To: T10 Technical Committee
From: Robert Sheffield, Intel (robert.l.sheffield@intel.com)
Date: 11 July 2005
Subject: 05-224r1 SAS-1.1: Clarify STP exceptions to SATA link protocol

This proposal is to move subclause 7.2.2.4 to subclause under 7.17 STP link layer, and to add text to 7.17.1 to clearly identify which elements of STP protocol represent exceptions to the ATA/ATAPI-7 link layer requirements that apply to SAS ports during an STP connection.

~~**Figure 125 — Transmitting a continued primitive sequence**~~

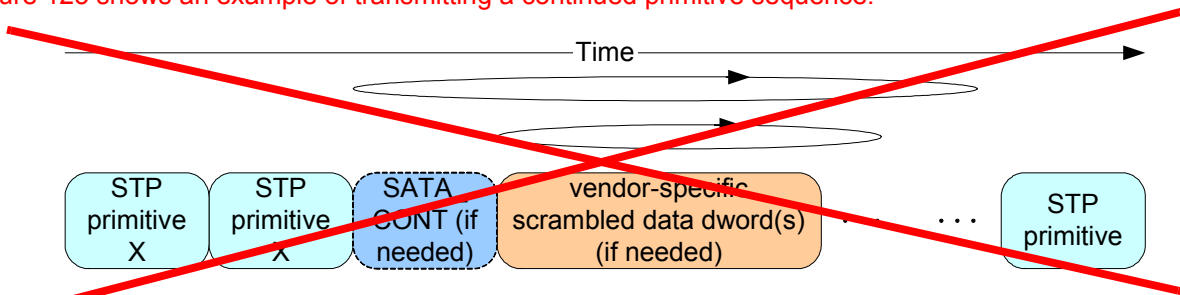
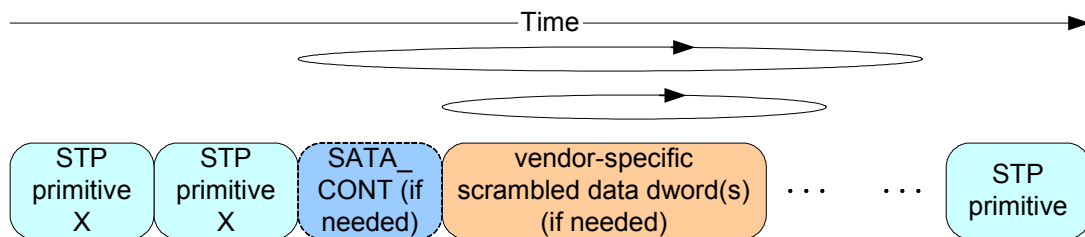
Primitives that form continued primitive sequences (e.g., SATA_HOLD) shall be transmitted two times, then be followed by SATA_CONT, if needed, then be followed by vendor-specific scrambled data dwords, if needed. ALIGNs and NOTIFYs may be sent inside continued primitive sequences as described in 7.2.4.1. [Specific requirements for SATA_CONT are described in 7.17.2.](#) ~~After the SATA_CONT, during the vendor-specific-scrambled data dwords:~~

- ~~a) a SATA_CONT continues the continued primitive sequence; and~~
- ~~b) any other STP primitive, including the primitive that is being continued, ends the continued primitive sequence.~~

~~Figure 125 shows an example of transmitting a continued primitive sequence.~~

~~Receivers shall detect a continued primitive sequence after at least one primitive is received. The primitive may be followed by one or more of the same primitive. The primitive may be followed by one or more SATA_CONTs, each of which may be followed by vendor-specific data dwords. Receivers shall ignore invalid dwords before, during, or after the SATA_CONT(s). Receivers do not count the number of times the continued primitive, the SATA_CONTs, or the vendor-specific data dwords are received (i.e., receivers are simply in the state of receiving the primitive).~~

Primitives that form continued primitive sequences (e.g., SATA_HOLD) shall be transmitted two times, then be followed by SATA_CONT, if needed, then be followed by vendor-specific scrambled data dwords, if needed. ALIGNs and NOTIFYs may be sent inside continued primitive sequences as described in 7.2.4.1. After the SATA_CONT, during the vendor-specific scrambled data dwords:

- a) a SATA_CONT continues the continued primitive sequence; and
- b) any other STP primitive, including the primitive that is being continued, ends the continued primitive sequence.

Figure 152 shows an example of transmitting a continued primitive sequence.

Figure 126 — Receiving a continued primitive sequence

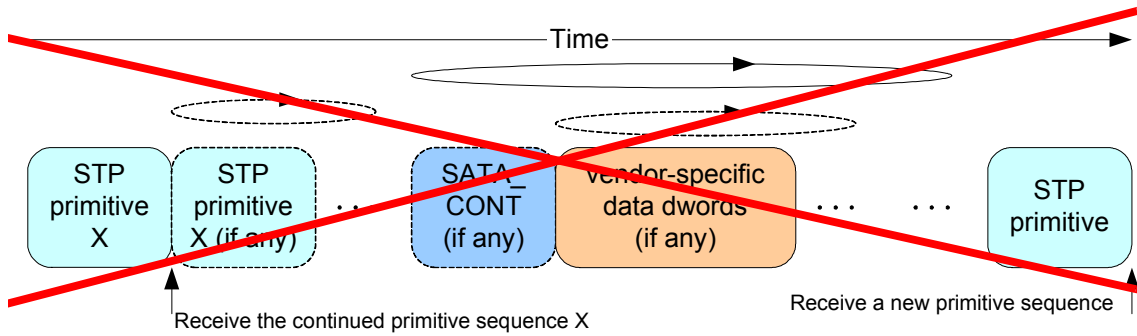
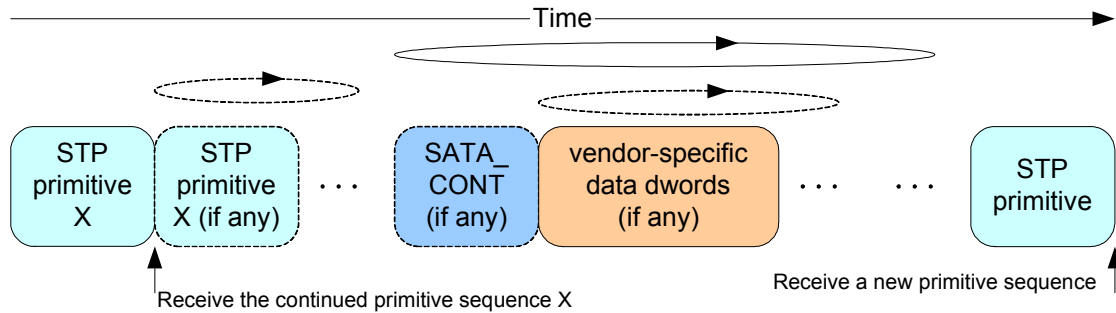
Figure 126 shows an example of receiving a continued primitive sequence.

Figure 153 shows an example of receiving a continued primitive sequence.

Figure 154 — STP flow control

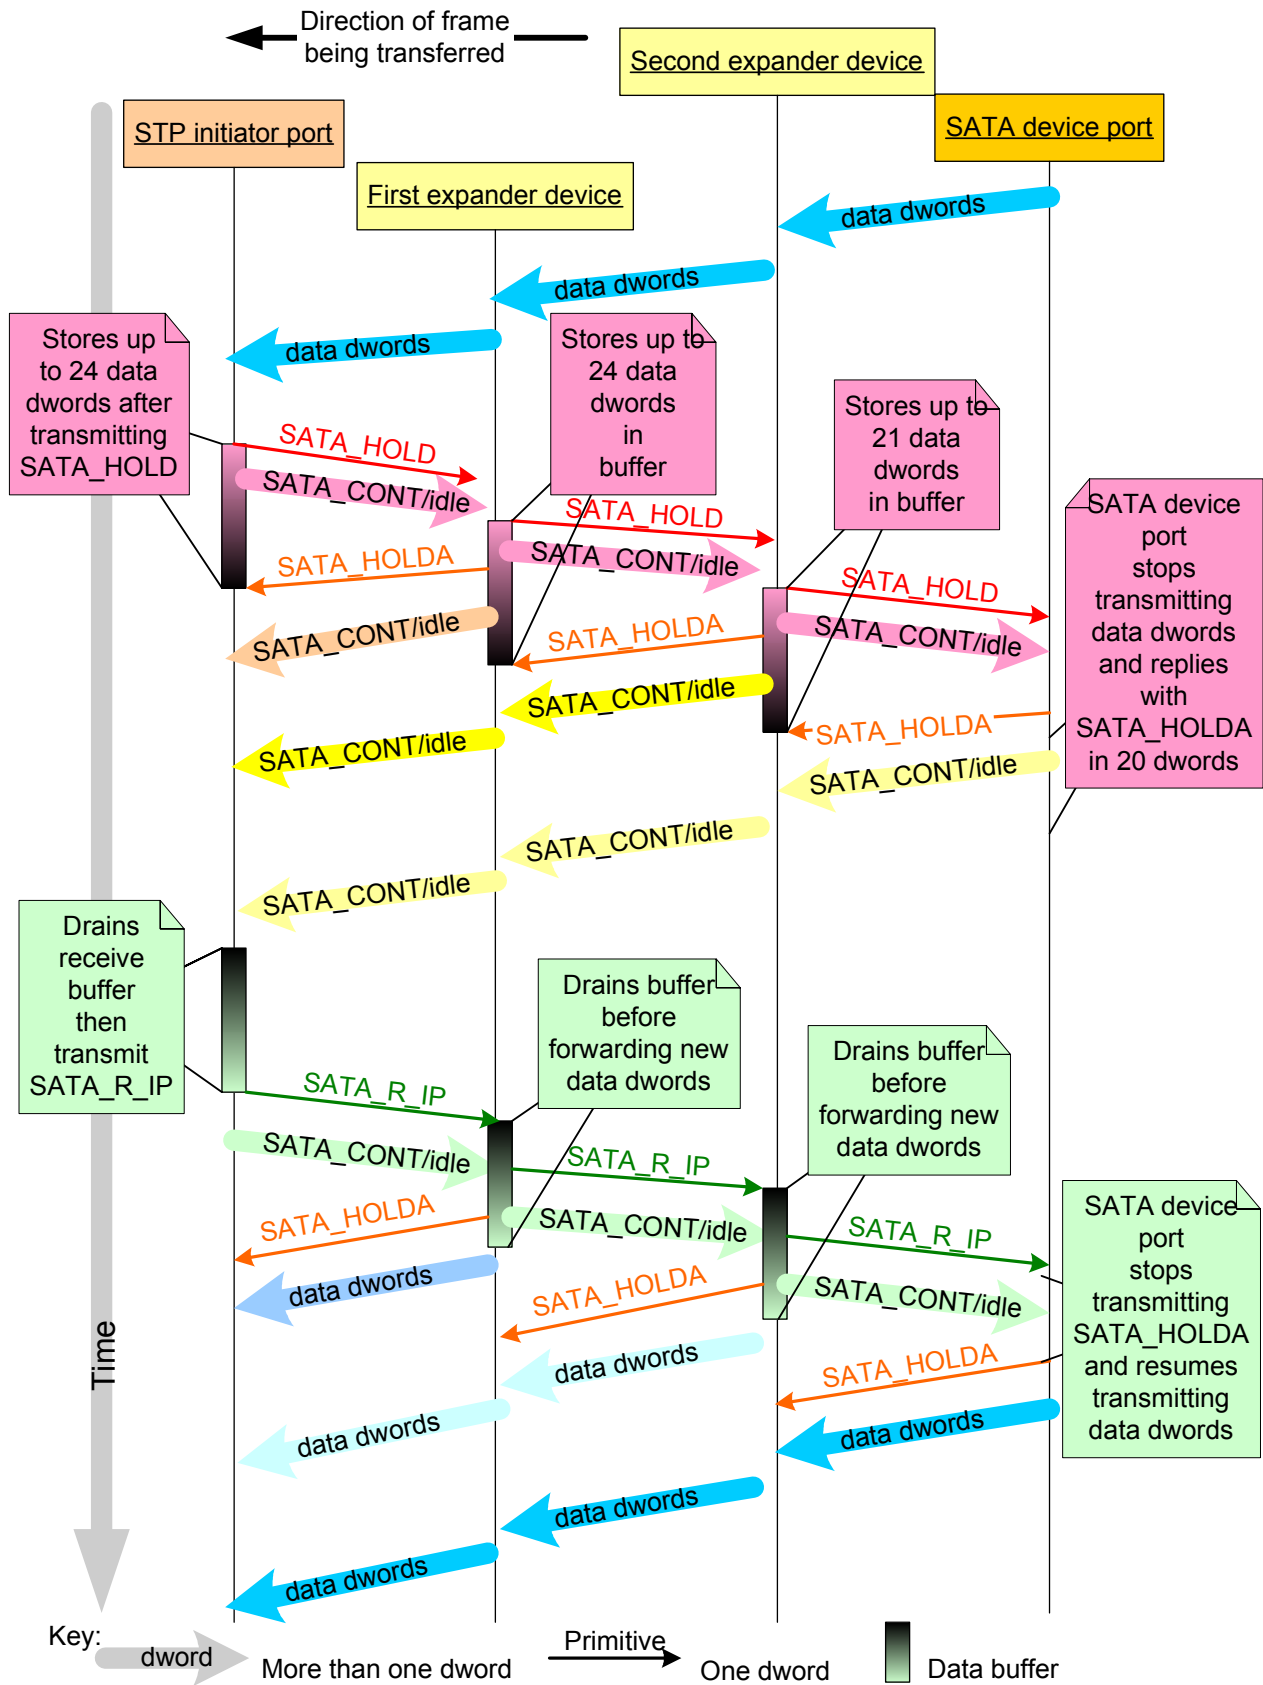
[Figure 154](#) shows STP flow control between:

- a) an STP initiator ~~port~~ phy receiving a frame;
- b) an expander device (the first expander device);
- c) an expander device with an STP/SATA bridge (the second expander device); and
- d) a SATA device ~~port~~ phy transmitting a frame.

After the STP initiator ~~per~~ [phy](#) transmits SATA_HOLD, it receives a SATA_HOLD_A reply from the first expander device within 24 dwords (for a 1,5 Gbps physical link). The first expander device transmits SATA_HOLD to the second expander device and receives SATA_HOLD_A within 24 dwords (for a 1,5 Gbps physical link), buffering data dwords it is no longer able to forward to the STP initiator ~~per~~ [phy](#). The second expander device transmits SATA_HOLD to the SATA device ~~per~~ [phy](#) and receives SATA_HOLD_A within 21 dwords (for a SATA physical link), buffering data dwords it is no longer able to forward to the first expander device. When the SATA device ~~per~~ [phy](#) stops transmitting data dwords, its previous data dwords are stored in the buffers in both expander devices and the STP initiator ~~per~~ [phy](#).

After the STP initiator ~~per~~ [phy](#) drains its buffer and transmits SATA_R_IP, it receives data dwords from the first expander device's buffer, followed by data dwords from the second expander device's buffer, followed by data dwords from the SATA device ~~per~~ [phy](#).
